PARKS BOARD MEETING - South Whidbey Aquatic Center Project Budget

SOUTH WHIDBEY AQUATIC CENTER
SCHEMATIC DESIGN - AUGUST 2023

SD DESIGN COST ESTIMATE

floor plan 1 (VE savings)

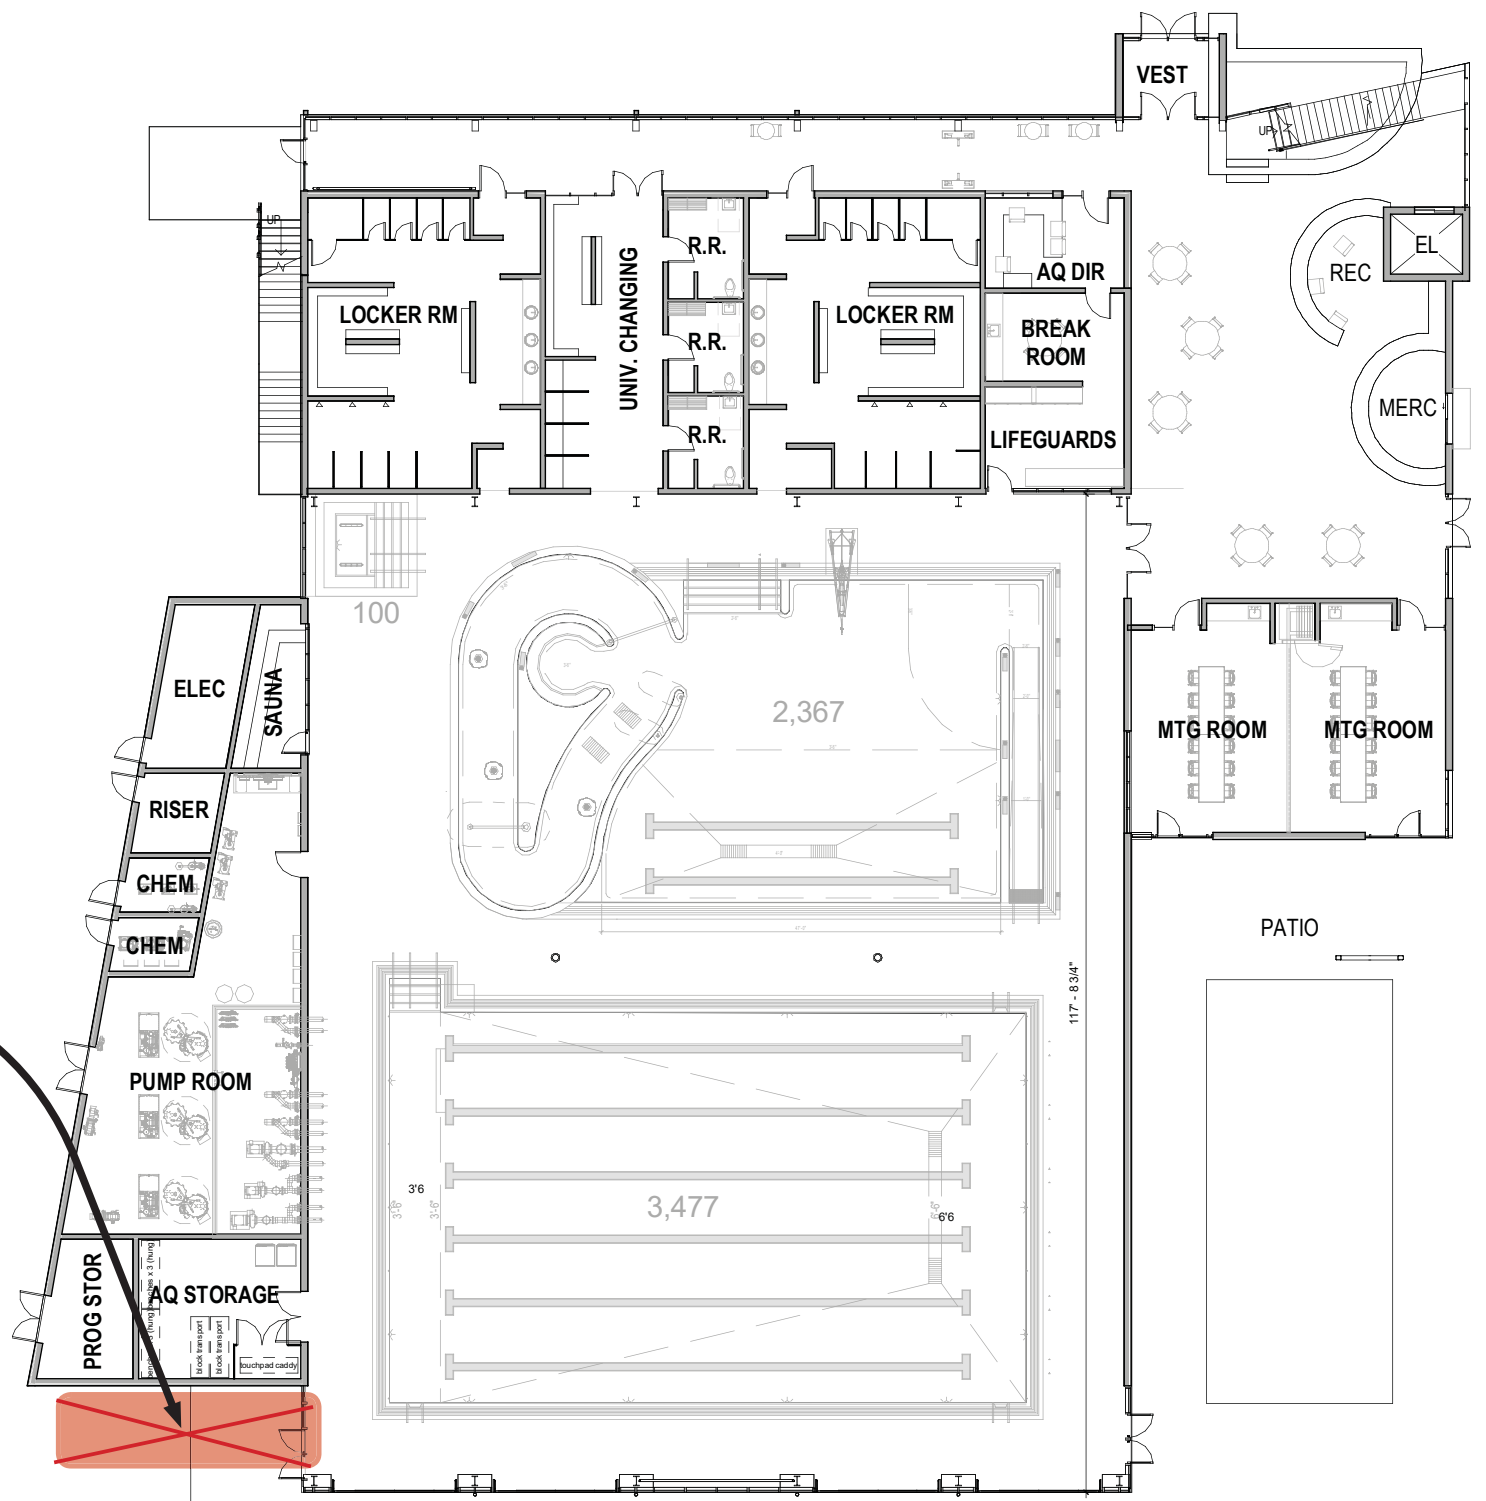
Pathway 1 includes a cut to a programmatic offering in the form of **the elimination of the walking track, reduction to the natatorium height (which was driven by the walking track), and the elimination of an egress stair required by the walking track.** There are considerable technical and user-experience challenges to the walking track which carry significant cost risks to the facility. The design team recommends that the walking track be included in the gymnasium in future Phase 2. For additional information, see altered floor plans on subsequent page and the appendix under the heading 'Pathway 1'.

Eliminate 3rd stair

floor plan 2 (VE savings)

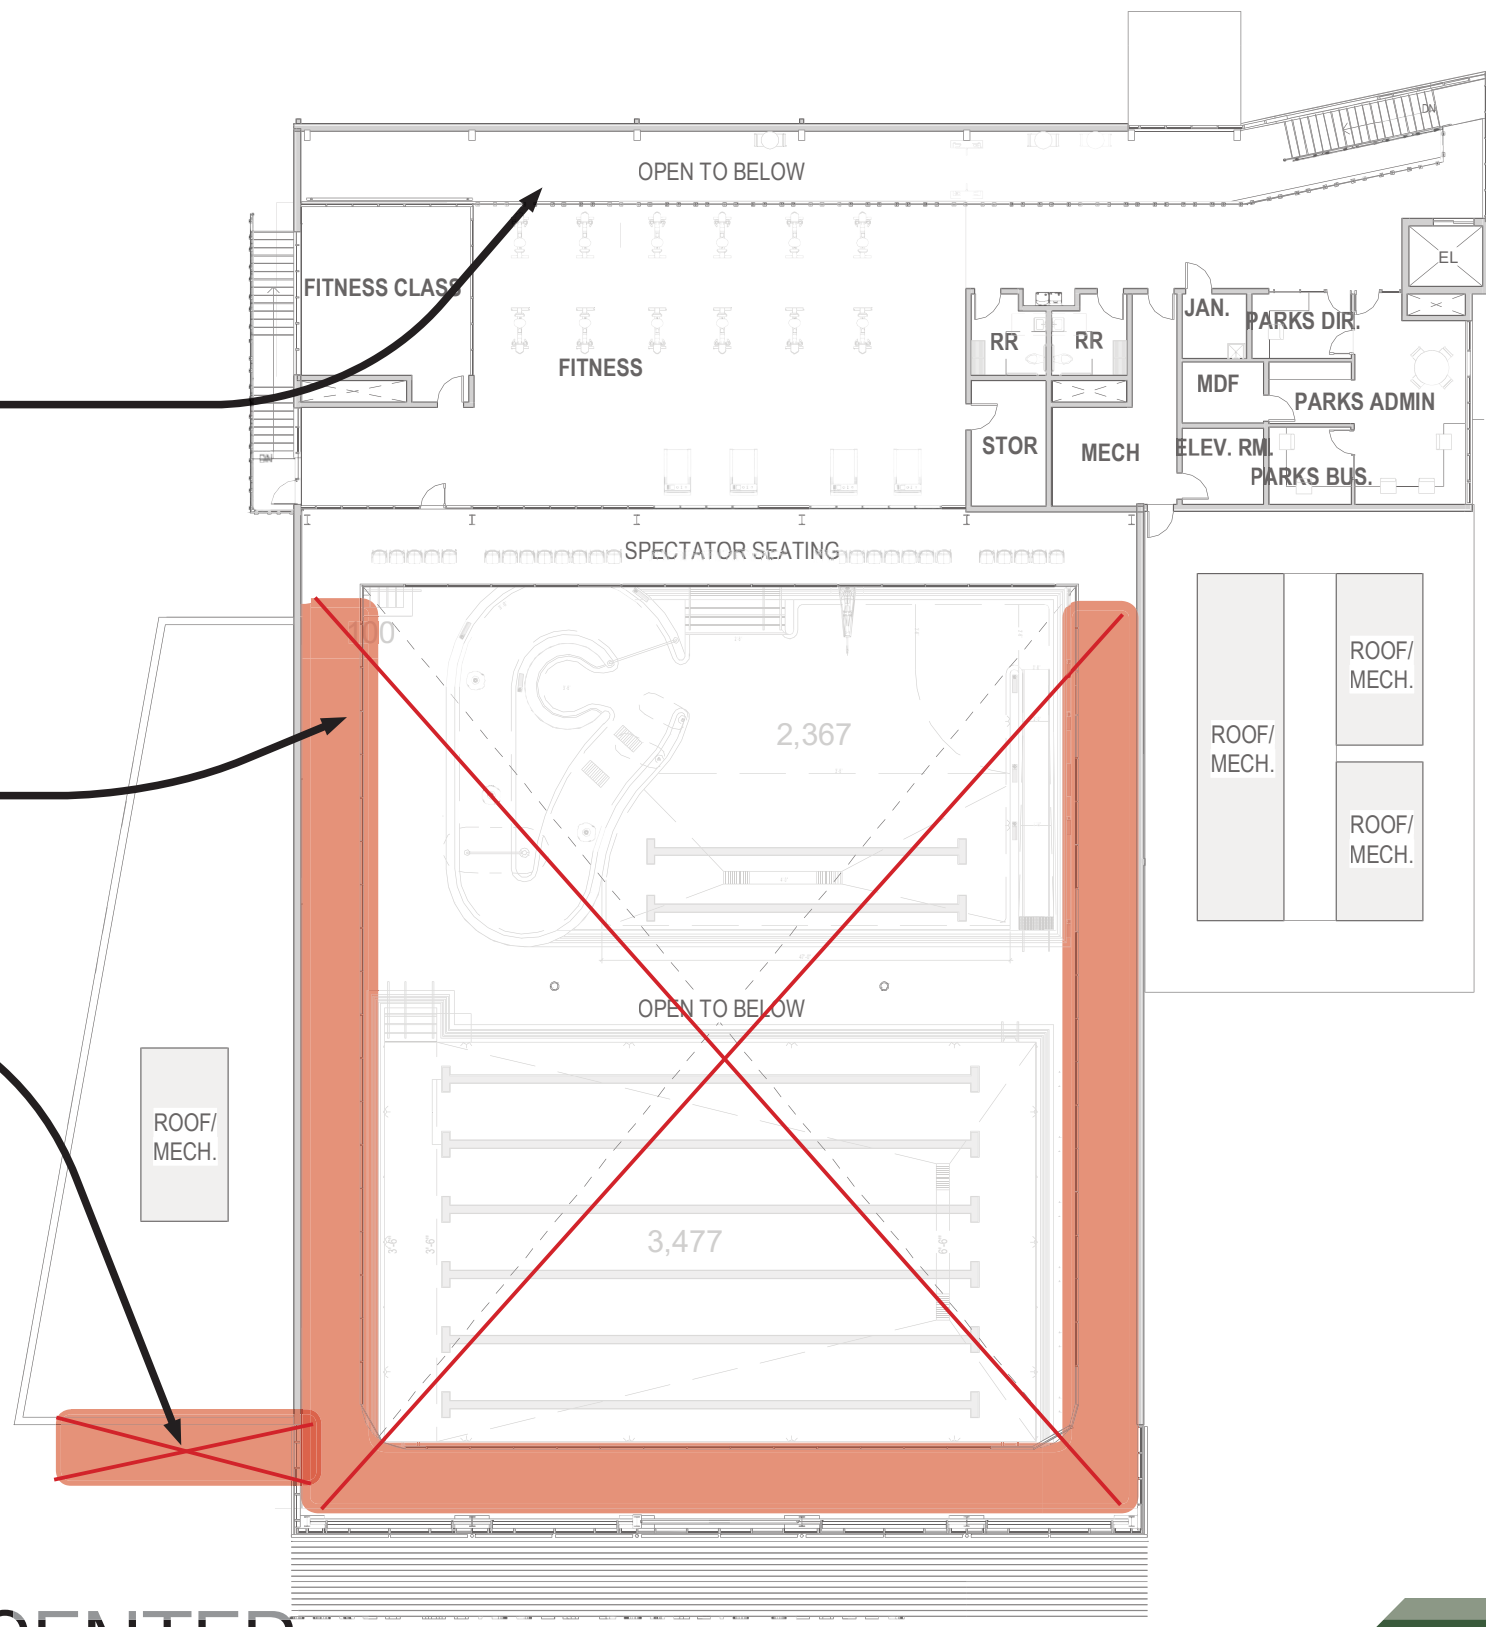
Remove acoustics at hall

Eliminate walking track

Eliminate 3rd stair

floor plan 1 (VE savings)

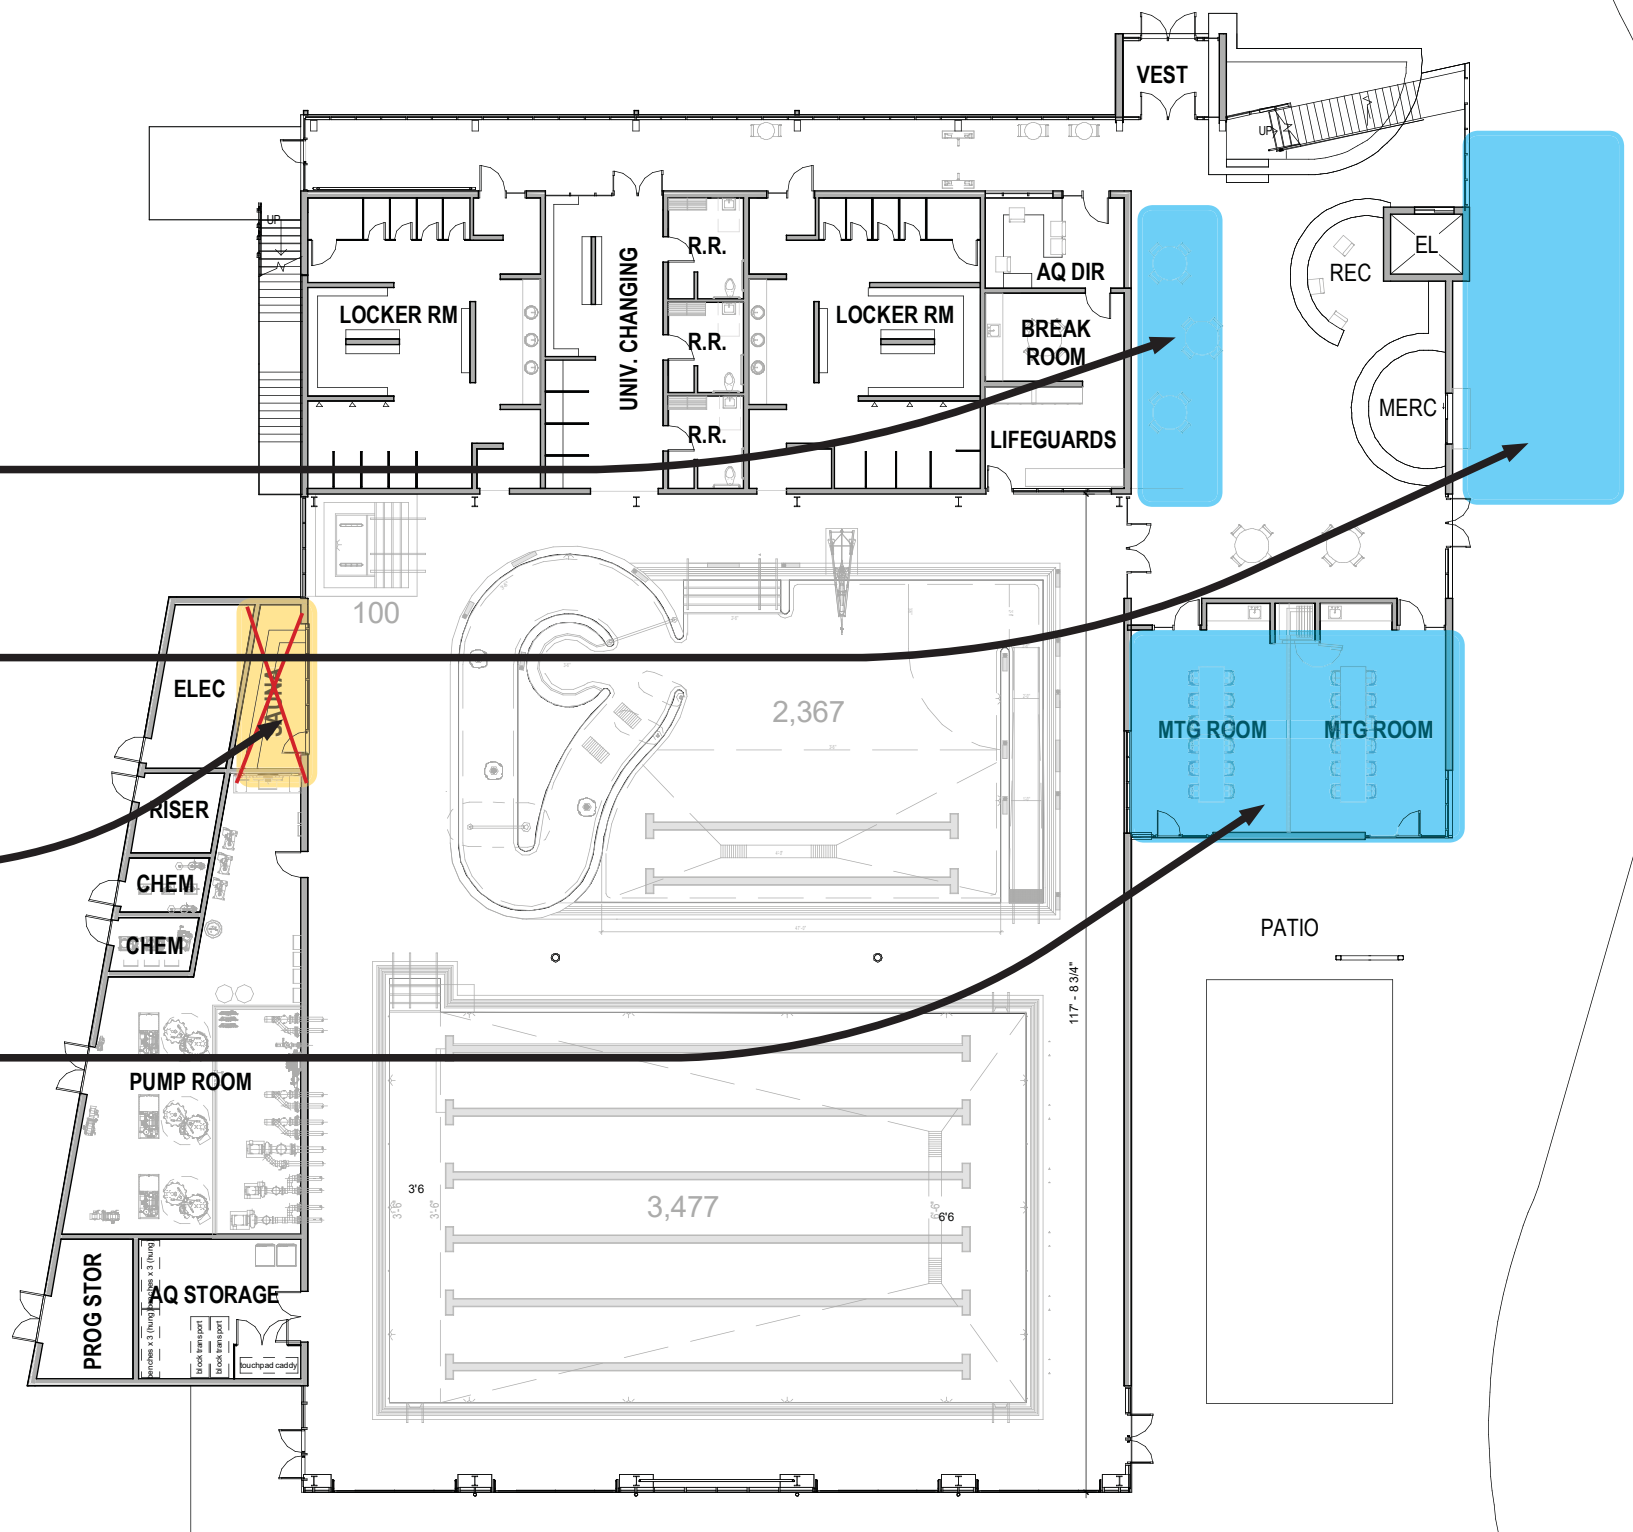
Mechanical (500 sf)

Parks Admin (1,000 sf)

Eliminate sauna

Party rooms/fitness class

floor plan 2 (VE savings)

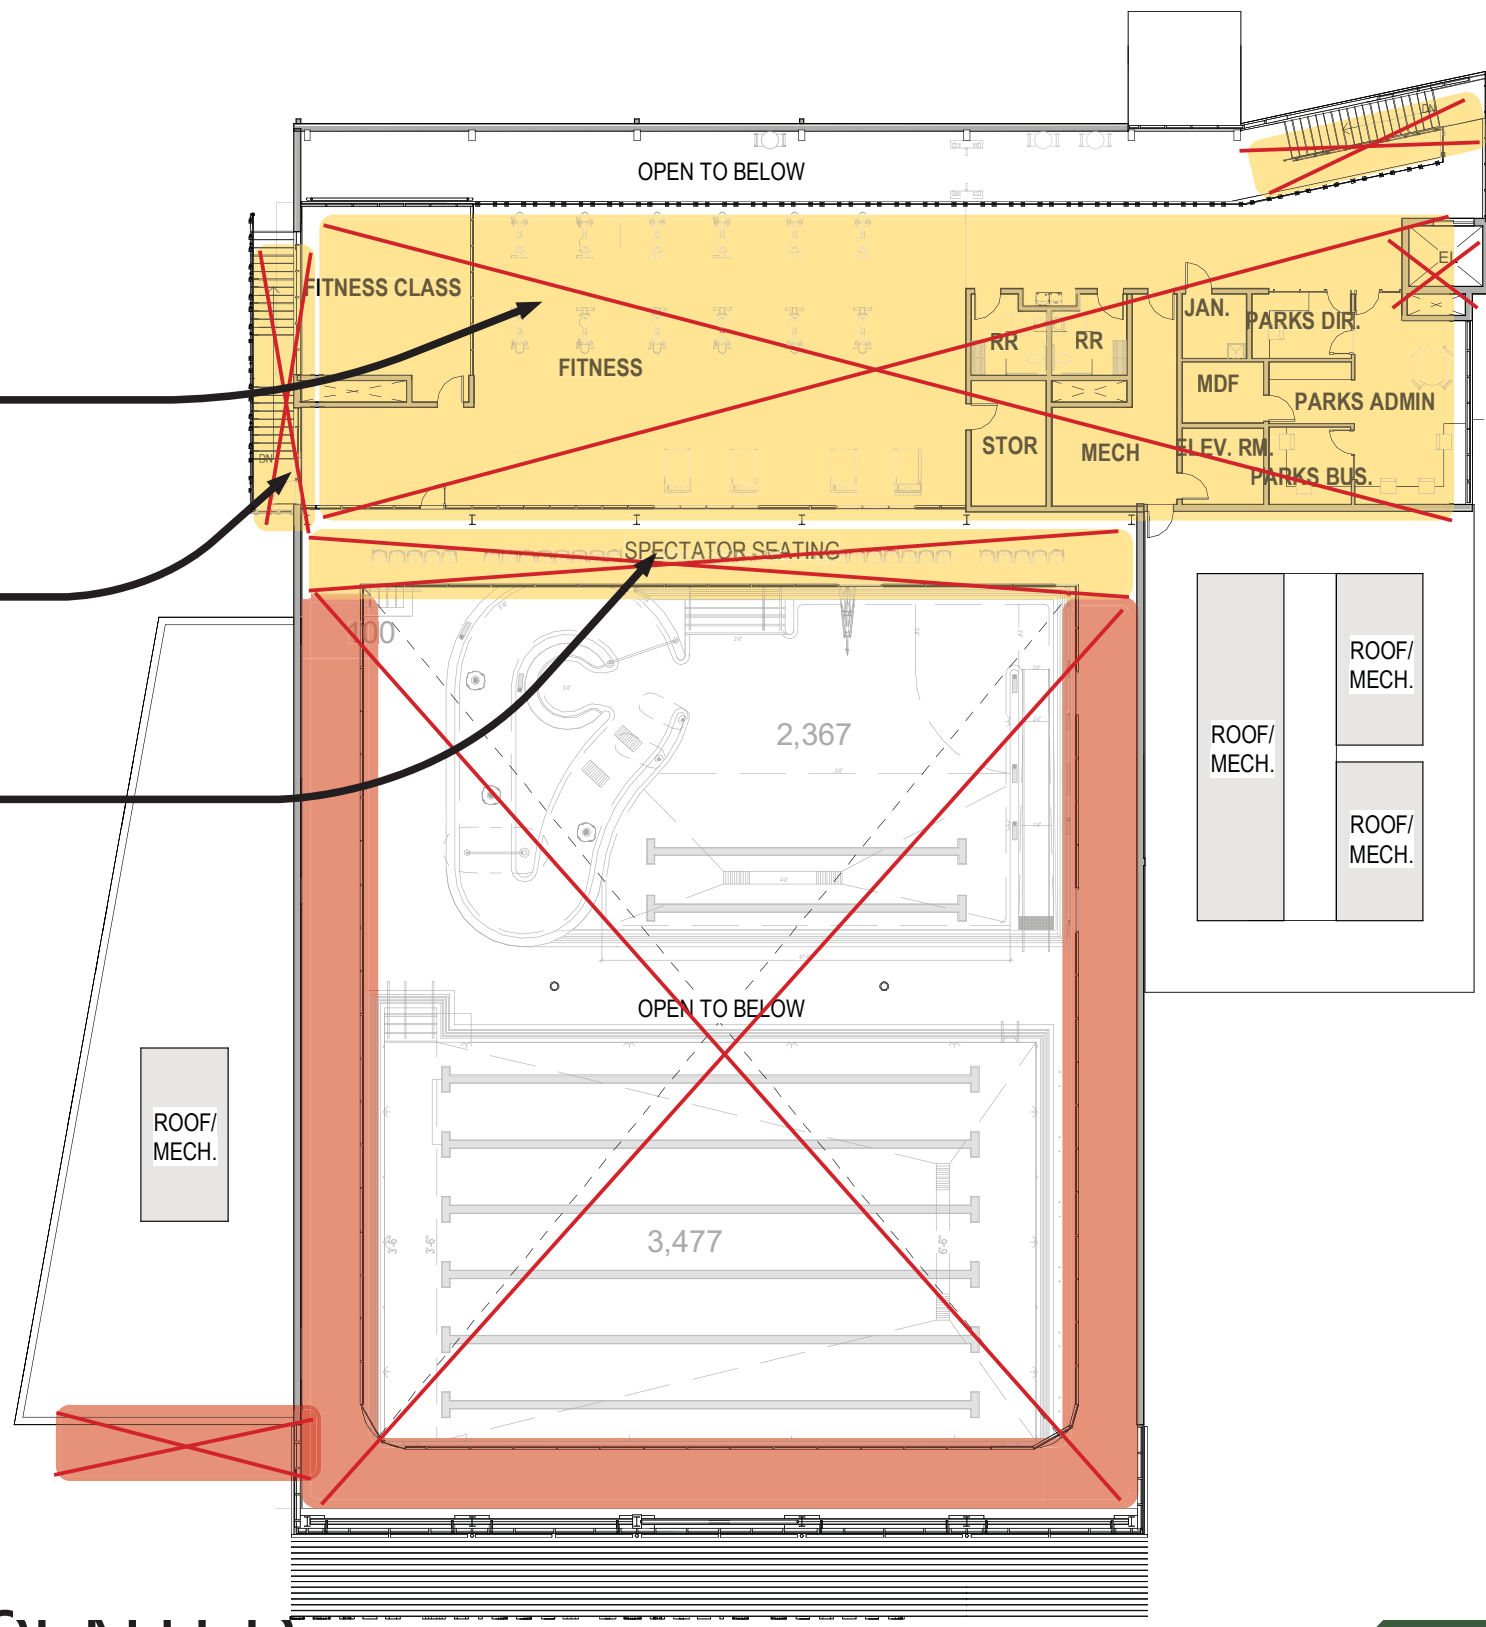
- Eliminate second floor
- Eliminate elevator and stairs
- Eliminate spectator seating
